WISDOM INDUSTRIES, INC.

# REQUIRED INSPECTION NOTICE

**DATE:** JULY 31, 1998  
**RIDE:** ORIENT EXPRESS  
**SUBJECT:** ROD END COUPLER GREASE ZERK HOLES  
**COMPLIANCE:** MANDATORY  
**COMPLETION DATE:** IMMEDIATELY

**SUBJECT: RODEND COUPLER ROLL PIN  
INSTALLATION**

<b>WISDOM INDUSTRIES</b> Merino, CO 80741		APPROVED BY:	DRAWN BY: JLC
		SCALE: NTS	REVISID
DATE: 7-19-96		DESCRIPTION	
CAR HITCH			
EQUIPMENT:		DRAWING NUMBER	
COASTERS		DWG #

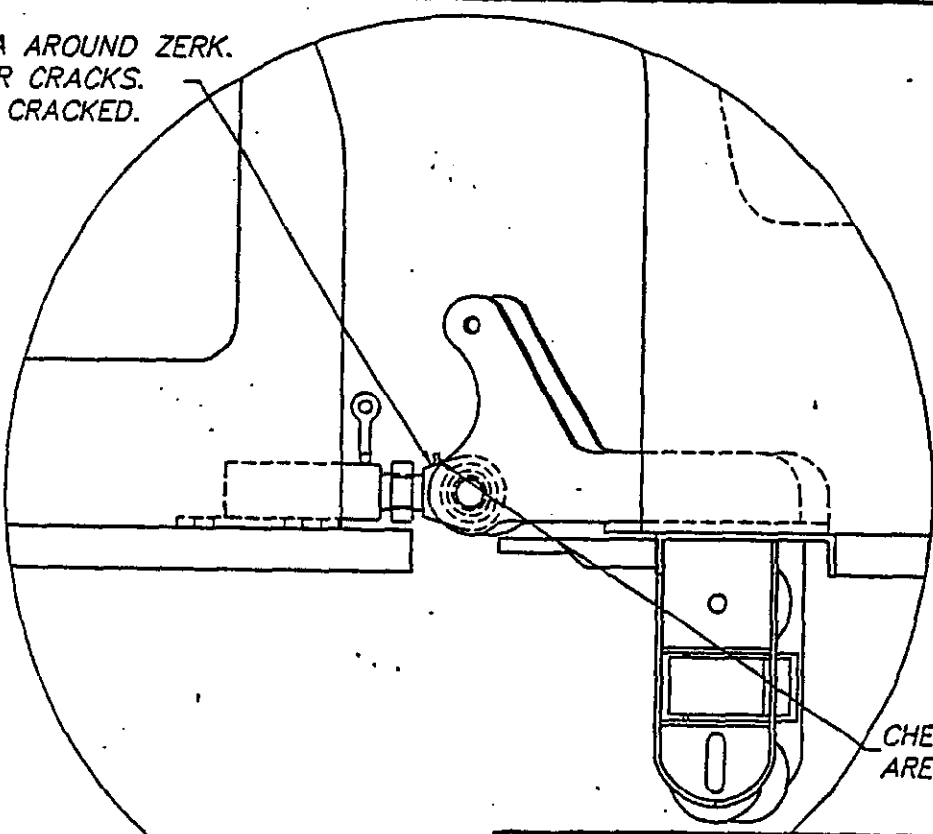
One coaster has has one rod end crack at the grease zerk hole. Inspect the rod end, between the cars for cracking in the grease zerk area.

CLEAN AREA AROUND ZERK.  
INSPECT FOR CRACKS.  
REPLACE IF CRACKED.

CHECK GREASE ZERK  
AREA FOR CRACKS.

1. Thoroughly clean the area around the grease zerk.
2. Inspect the area around the ground zerk for cracks.
3. If there is a question about cracking use a dye penetrant kit to check for cracks.
4. If no cracks are found include a check of the grease zerk area in the daily inspection of the ride.
5. If the rod end is cracked replace the rod end.

<b>WISDOM INDUSTRIES</b> Merino, CO 80741		SCALE: NTS	APPROVED BY: <i>mtg/pt</i>	DRAWN BY: JJR
		DATE: 12-14-00		REVISED
DESCRIPTION CAR HITCH MODIFICATION				
EQUIPMENT: COASTERS			DRAWING NUMBER HITCH MOD

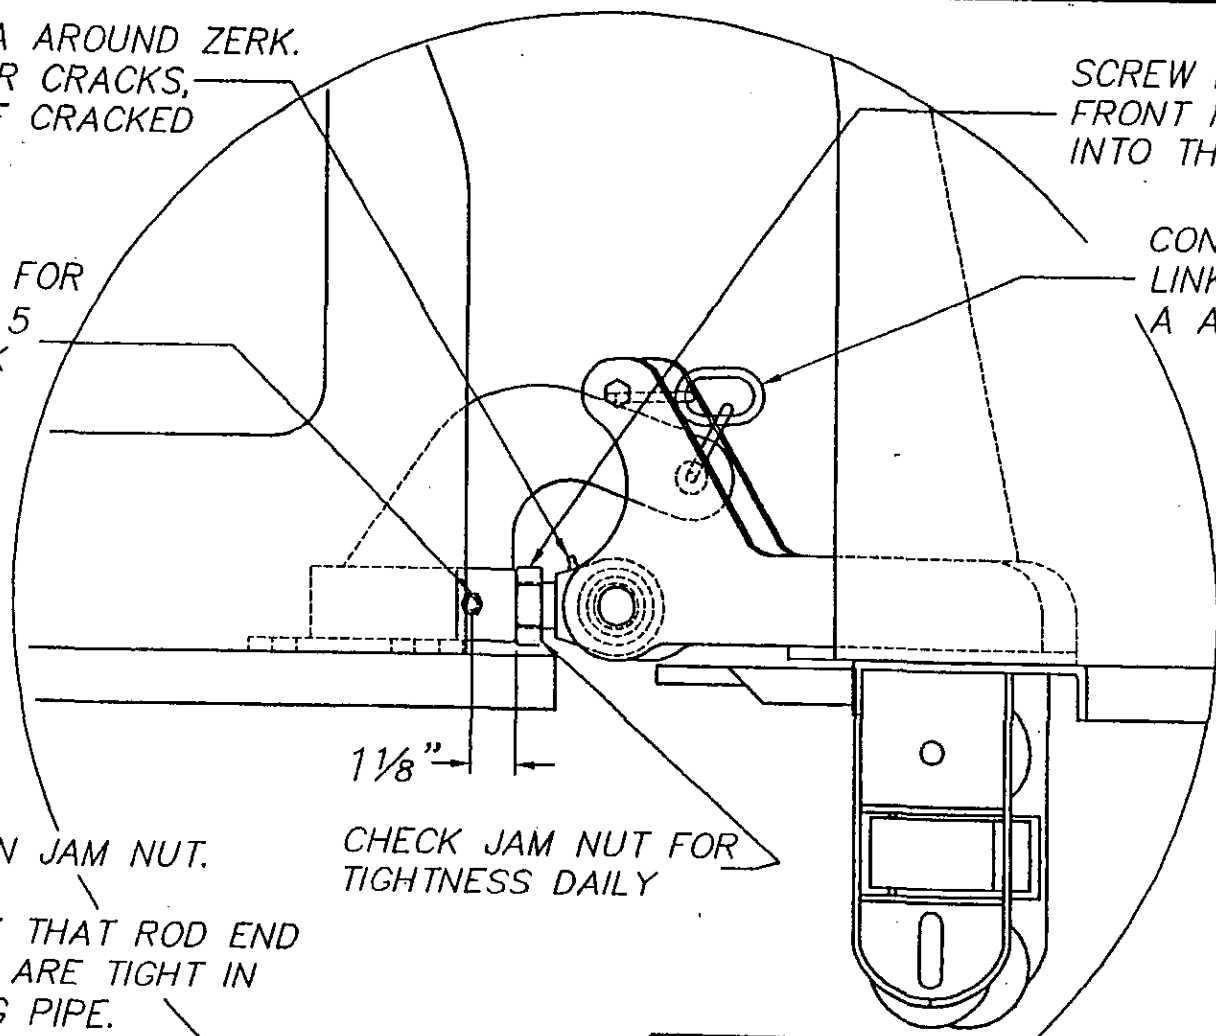
SCREW ROD END INTO  
FRONT HITCH COMPLETELY  
INTO THREADED HOUSING.

CROSS DRILL FOR  
5/16 GRADE 5  
BOLT. & LOCK  
NUT.

CHECK JAM NUT FOR  
TIGHTNESS DAILY

1. Detach rodend eye from rear of car
2. Turn Jam nut until it is next to eye of rodend.
3. Screw rodend into front hitch threaded mount till threads bottom on jam nut.
4. Turn rodend out only enough to make the eye vertical and grease zerck is up.
5. Tighten jam nut.
6. Reattach rodend to rear of car with original 1" bolt. Use new lock nut.
7. Tighten 1" bolt and lock nut.
8. Run ride and check for clearance between cars in turns.
  - ◆ **NOTE: IF THERE IS NOT ADEQUATE CLEARANCE BETWEEN CARS CALL FOR AN EXTENDED FRONT HITCH MOUNT.**
9. Check for clearance between car rear bracket and shank of rodend. (See drawing)
10. If bracket is hitting rodend shank grind edge of rear bracket for clearance.

11. Measure 1 1/8" from where jam nut touches front hitch threaded mount. (See Drawing)
12. Cross drill threaded coupler mount for a 5/16 " bolt.
13. Install a 5/16 X 3" grade 5 bolt and lock nut and tighten.
14. Repeat for other rodends.

<b>WISDOM INDUSTRIES</b> Merino, CO 80741	
SCALE: NTS	APPROVED BY: 
DATE: 12-14-00	DRAWN BY: JJR
DESCRIPTION	
CAR HITCH	
EQUIPMENT:	DRAWING NUMBER:
COASTERS	HITCH MOD

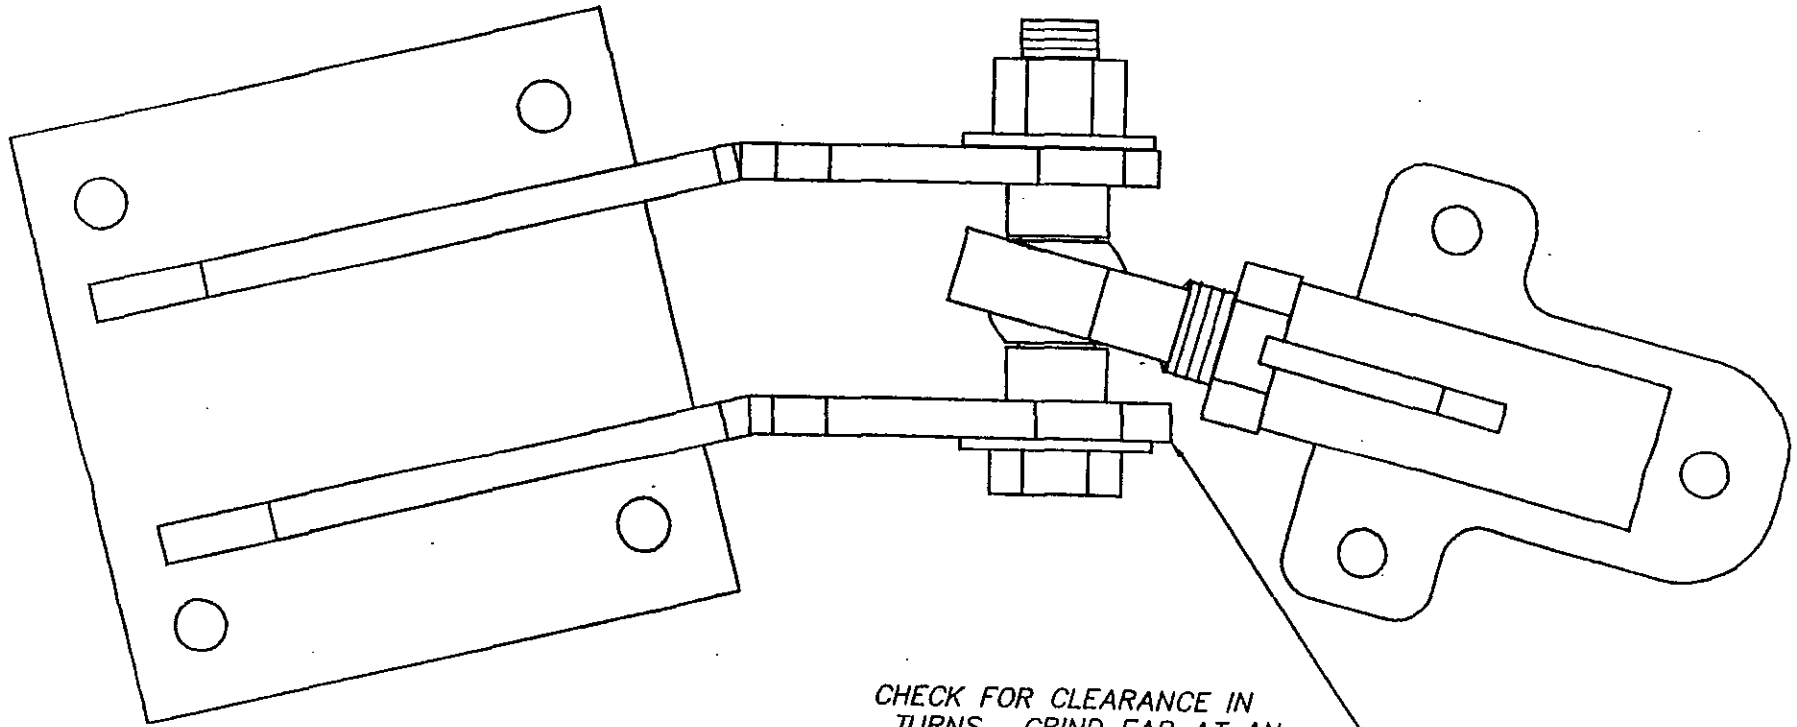
CHECK FOR CLEARANCE IN  
 TURNS. GRIND EAR AT AN  
 ANGLE TO CLEAR ROD END  
 SHANK.

1. LOOSEN JAM NUT.

2. CHECK THAT ROD END  
THREADS ARE TIGHT IN  
MOUNTING PIPE.

3. TIGHTEN JAM NUT.
